# Modification 1 Penrith Lakes Employment Lands Subdivision and Works

Modification Assessment Report (DA9876-Mod-1)

January 2024

**Figure 4** | Intersection of Castlereagh Road and Lugard Street. Deceleration left turn lane (Red) and southbound right turn lane (Yellow) (Source: Nearmaps as annotated)

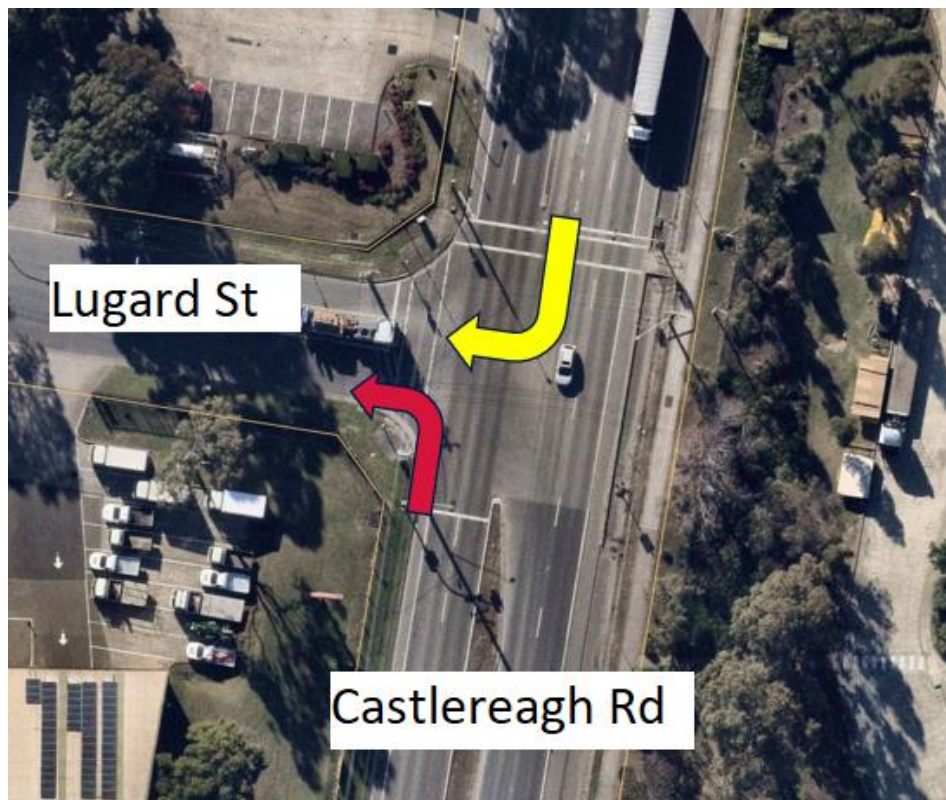
The applicant has sought a modification to the development consent to delete condition C23(b). The condition requires the provision of a deceleration lane at the intersection of Castlereagh Road and Lugard Street as outlined in Figure 4.

The revised report concluded that *'there is no clear and obvious benefit that would result from the addition of the left turn lane. Conversely, there are disbenefits as outlined above in addition to the disruption of traffic flows along Castlereagh Road that would occur during construction'*. Further to this, the report outlined that the provision of the left turn lane would have an adverse impact on the efficiency of the right turn southbound traffic movement into Lugard Street (Identified in yellow in Figure 4).

The Department considers that the applicant's traffic modelling has not demonstrated that the left turn deceleration lane would not have any benefit on the operation of the intersection. The Department notes that the traffic modelling is isolated to the intersection of Lugard Street and Castlereagh Road, and has not considered any impacts of the removal of the turning lane on other intersections (particularly intersections on Castlereagh Road to the south of Lugard Street).

The provision of a standalone turning lane would improve through traffic flows by removing turning vehicles from the lefthand northbound lane. Further to this, the applicant's traffic model highlights that the queue length for the left turn lane would significantly reduce. Table 6 below provides a summary of the intersection results for left turn movements extrapolated from the applicant's traffic modelling reports.

As can be seen in both the AM and PM peak for both the traffic distribution of 30% and 50% using Lugard Street, there is a significant reduction in queue lengths for vehicles turning left in both the AM and PM peak periods. This represents a significant number of vehicles removed from the

through traffic lanes on Castlereagh Road, ensuring an improvement in northbound through traffic movements. It is noted that there does appear to be a disproportionate queue length for the 50% traffic distribution in the AM.

In this instance, the queue lengths associated with the removal of condition C23(b) reduce through traffic to a single lane, thereby compromising the efficiency of that traffic movement, likely having flow on impacts to intersections to the south of Castlereagh Road and Lugard St.

- the removal of the left turn deceleration lane would result in a reduced performance of the intersection and the surrounding road network
- There is an identified benefit by providing the left turn lane through the significant reduction in queue lengths
- The reduced queue lengths removes vehicles from the 'through' traffic lanes, improving the efficiency of through traffic
- The revised traffic distribution provided by the applicant has demonstrated that the problem is exacerbated with increases in traffic distribution
- TfNSW and Council are not supportive of the deletion of condition C23(b)
- The removal of Condition C23(b) is not in the public interest as there is an identified disbenefit from the removal of the requirement to provide the left turn lane.

- the left turn deceleration lane is required to ensure the efficient operation of the Castlereagh Road and Lugard Street intersection
- the removal of the requirement to provide the left turn deceleration lane is not supported as it would result in reduced efficiency of the intersection
